**Project #18-001
Logan Meadows Business Park
Located at 765 W. 1800 N.**

Project Name: Logan Meadows Business Park
Proponent / Owner: Glen Thompson / Rexer LLC
Project Address: 765 W. 1800 N.
Request: Design Review Permit
Current Zoning: Industrial Park (IP)
Type of Action: Quasi-Judicial
Hearing Date: January 11, 2018
Submitted By: Russ Holley, Senior Planner

Staff recommends that the Planning Commission **conditionally approve** a Design Review Permit for Project #18-001, Logan Meadows Business Park, in the Industrial Park (IP) zone located at 765 W. 1800 N., TIN #04-079-0006.

SITE PLAN
 SCALE: 1"=20'

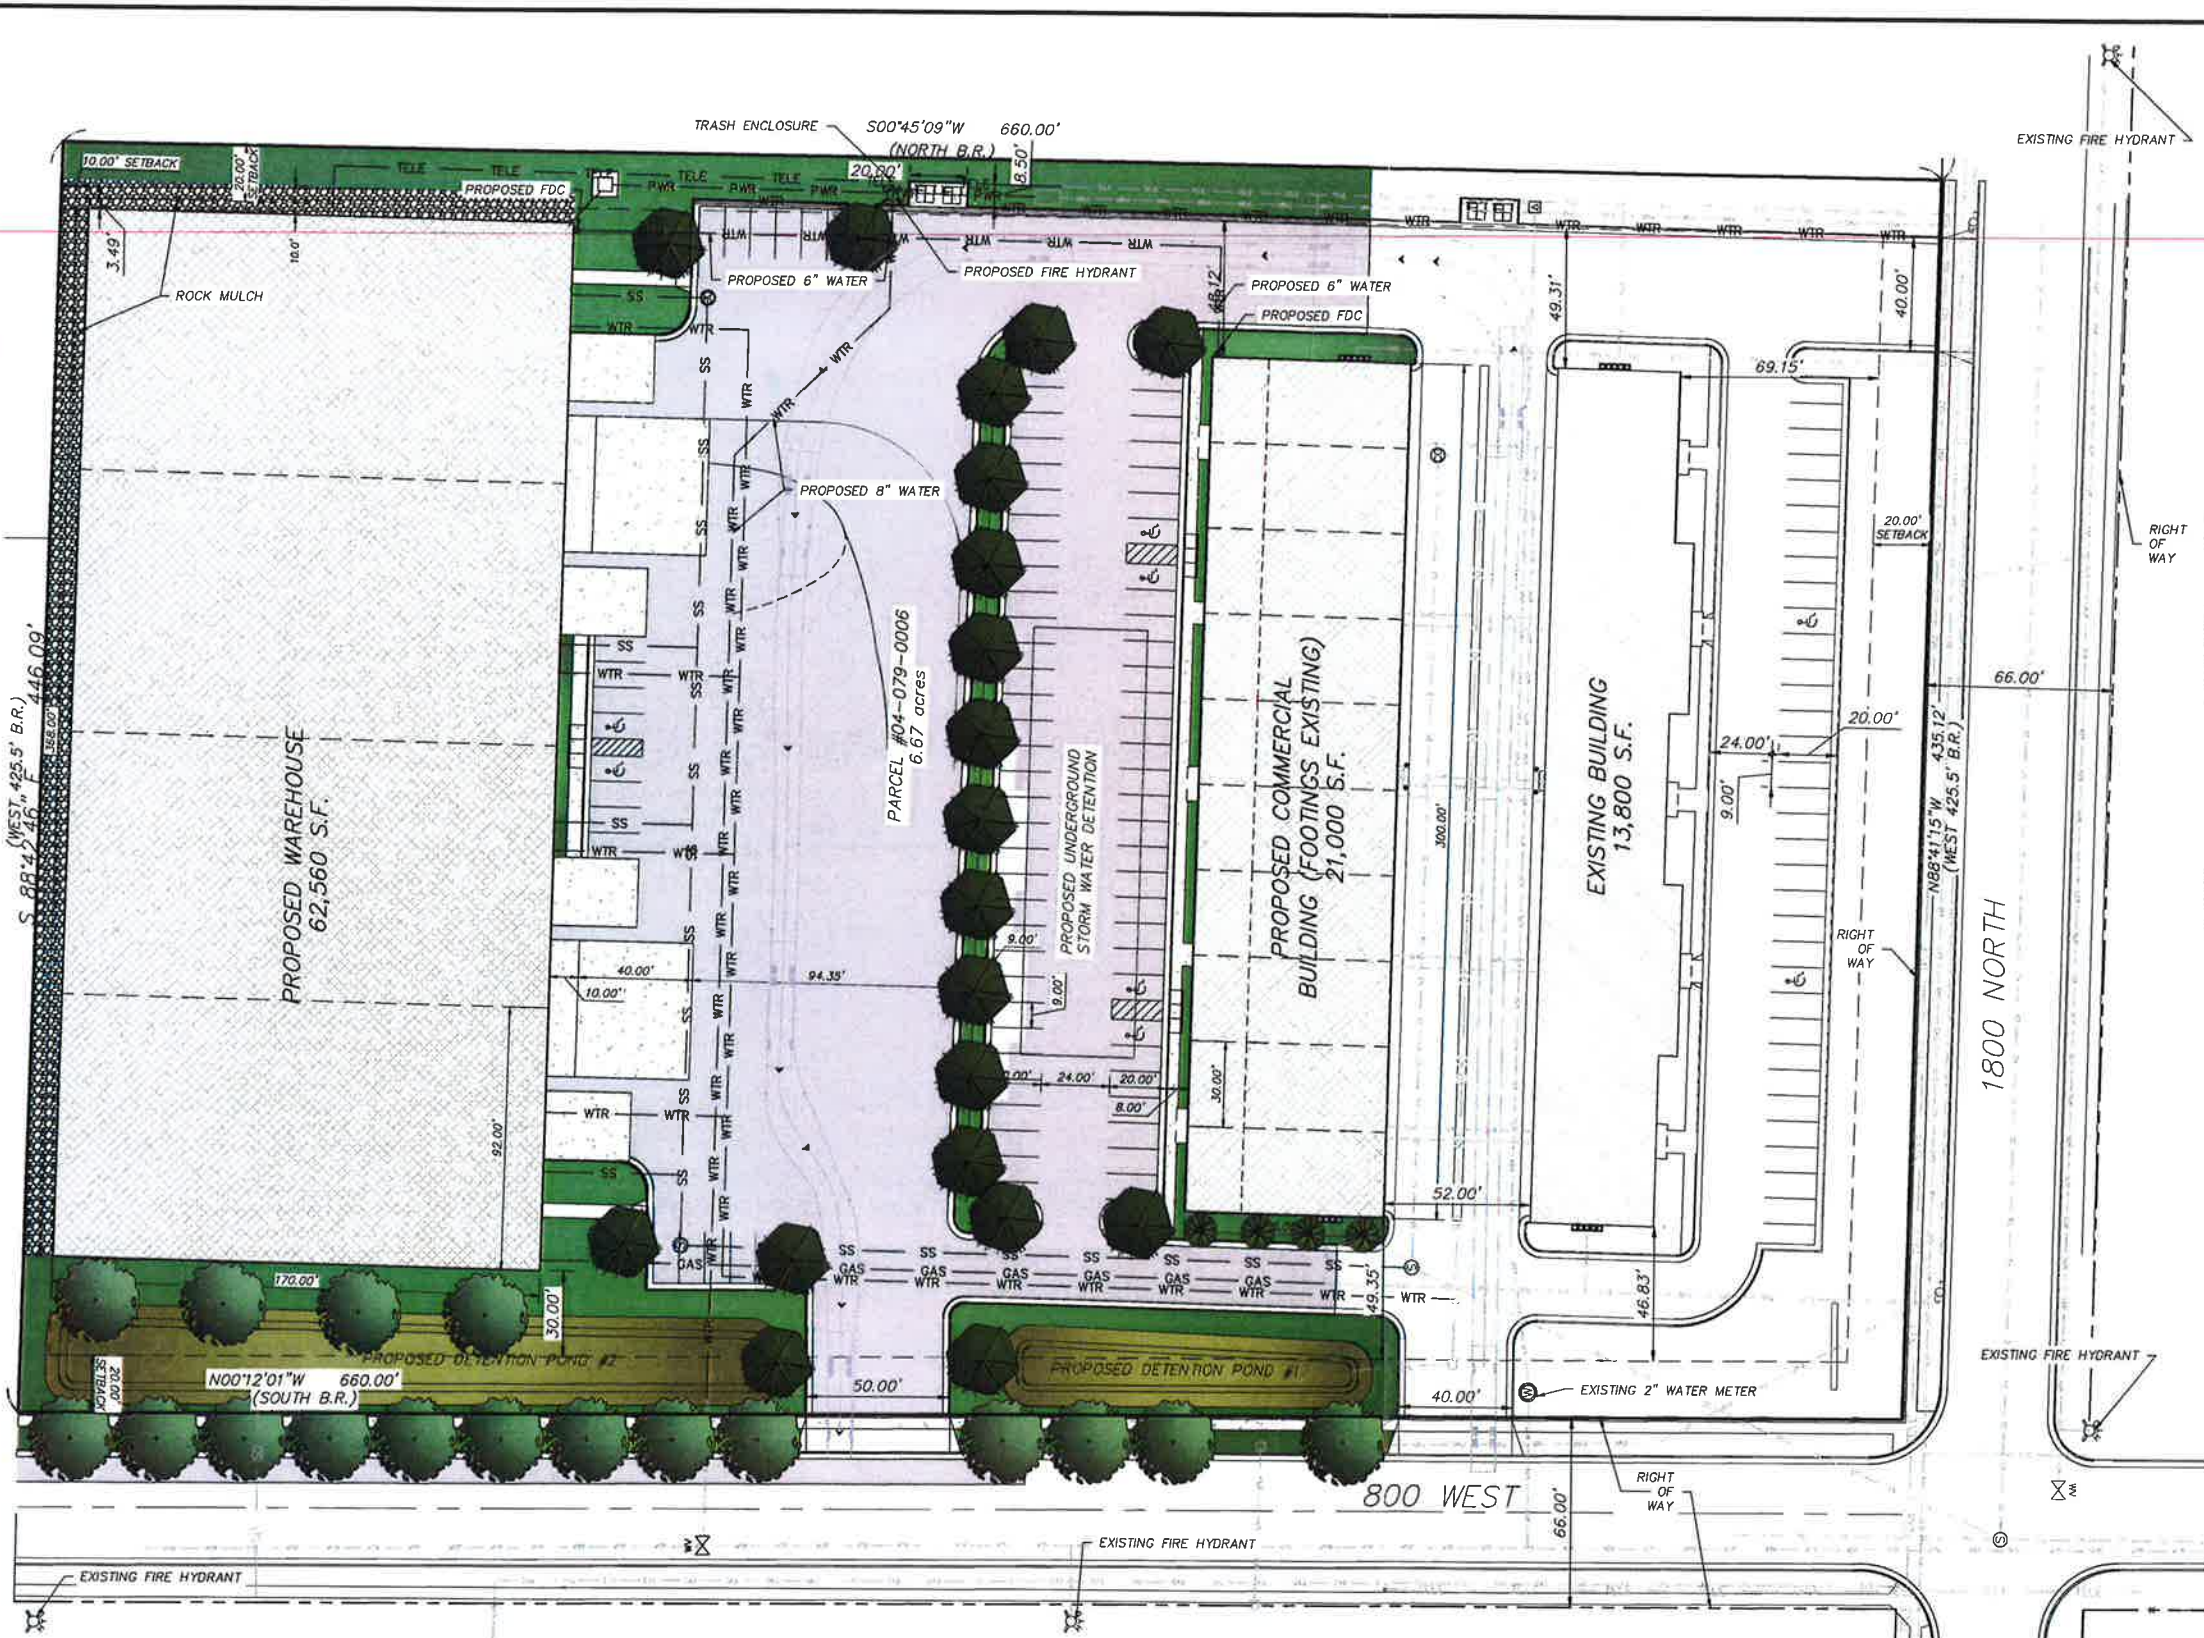
The LDC 17.37.160 requires pedestrian sidewalk connections throughout the site and between the building(s) and the adjacent streets. Sidewalks are only proposed in limited areas and do not fully provide pedestrian connections between each building and the adjacent streets. As conditioned with additional sidewalks and delineated pedestrian ways that connect the building and the street, the project meets the pedestrian circulation requirements of the LDC.

The LDC 17.38.070 requires one stall per every 300 SF commercial contractor/office space, and one stall per every 2000 SF warehouse or freight. Final parking requirements will be reviewed and approved when a Business License is proposed and the exact breakdown of commercial uses are indicated. For Design Review Permit approvals, it is important that an appropriate range of parking stalls will be available to accommodate different businesses and different area configurations. Based on their proposed breakdown of 12,600 SF of commercial space and 70,960 of warehouse space, a total of 77 parking stalls would be required as per the LDC. With 80 parking stalls proposed, the project meets the minimum requirements of the LDC as submitted.

The LDC 17.19.100 requires 10% open space and an additional 10% useable outdoor space of the project site. The LDC 17.35 generally describes open space as native vegetation or landscaped areas, while useable outdoor space is typically decks, patios, sidewalks and other similar amenities. The 6.67-acre total property area, including the existing building, would require 58,140 SF of landscaping and open space. The proposed project shows 59,689 SF of landscaping (20.5%), complying with minimum requirements of the LDC.

The LDC 17.39 requires minimum landscaping for overall visual aesthetics, ecological reasons, visual screening, shading purposes and enhancement of the outdoor experience. The LDC requires a minimum of 20 trees and a combination of 50 shrubs, flowers and ornamental grasses per acre. The project site for the two proposed buildings of 4.93-acres would require 98 trees and 246 shrubs, flowers and ornamental plants as per the LDC. As conditioned with a detailed landscaping plan, the project complies with the requirements of the LDC.

- Storm water shall be design for both the existing phase of project and the new. Current plans show the detention/retention pond for phase I being located where new building and parking is shown in Phase II.

- Per City Code, this development shall pay for 50% of the existing water line based on frontage length on 800 West.
 - Pipe existing irrigation/drainage ditch on north property line with an 18" pipe to match pipe placed to west of 1800 North

- Dedicate right of way as necessary for a 66' ROW on 800 West.
 - Show where water and sewer will connect to existing system for water and sewer. Each building shall have its own separate sewer and water (metered) services. If new warehouse has 4 bays or less that will be rented/leased or possibly subdivided in future each unit shall have separate services. If 5 or more a master meter will be allowed.

1. All standard conditions of approval will be recorded with the Design Review Permit and are available in the Community Development Department.
2. Additional sidewalks and delineated walkways shall be provided on-site that connect both buildings and the street sidewalk along 800 West.

3. Streetscape improvements along the 800 West frontage that include sidewalk and park-strips will be required.
4. The west building elevation on the smaller (southern) building shall include a canopy, doorway and a series of windows similar to that shown on the north elevation that total 30% transparency on that facade.

- a) A total number 98 trees and 246 shrubs, perennials and grasses shall be provided.
 - b) Street trees shall be planted along 800 West every 30 feet on center.

8. The project shall provide 80 parking stalls. Individual businesses will be reviewed for parking compliance when a business license is submitted.
9. Exterior lighting shall be limited to 32 feet in height and shall be concealed source, down-cast and shall not illuminate or cast light onto adjacent properties.

BUILDING ELEVATIONS
SCALE: N.T.S.

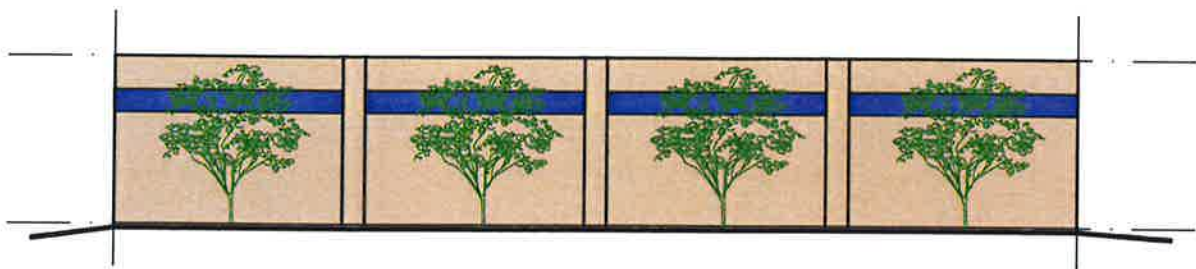
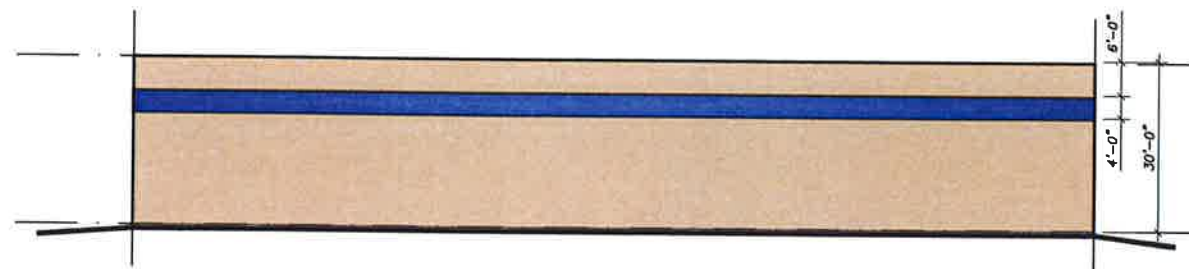
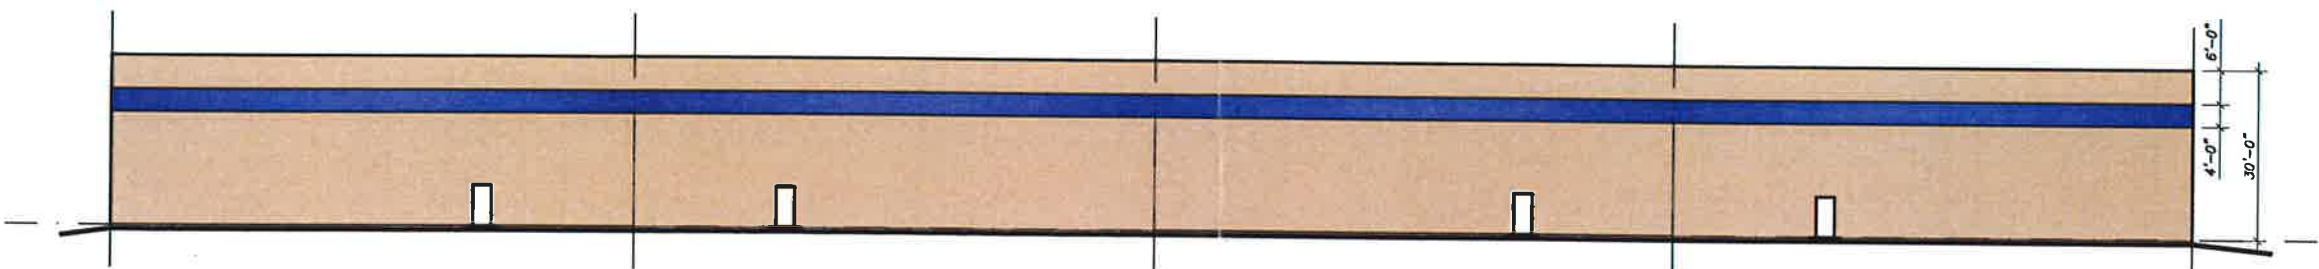
The proposed 30' tall concrete block buildings show a tan base color and a blue horizontal color stripe with a series doors and windows. For the two street facing facades (west), additional columns were added on the warehouse building. The vast majority of the proposed architectural features on the buildings are oriented towards each parking lot. The Planning Commission has the authority to reduce/alter/shift design requirements based on unique situations or building uses (LDC 17.50.080.C.5). In the case of the warehousing building (larger building), 30% transparency on street facing facades is a design requirement that conflicts with typical stacking of goods associated with warehouse building uses. A design alteration would be, in lieu of windows, additional façade features that accomplish the same purpose of attractive street appeal. For the smaller building that is planned for commercial contractor building uses, the 30% transparency requirement is appropriate and would not directly conflict with the building use. As conditioned with additional architectural design treatments on the west façade of the buildings, the project meets the requirements of the Land Development Code.

5. For the larger warehouse building (northern), the Planning Commission utilizes the authority in 17.50.080 to alter the 30% transparency design requirements for series of trellis features adjacent to the wall that mimic windows and create an area that is 30% of the wall area in addition to the proposed columns and color stripe on that facade.
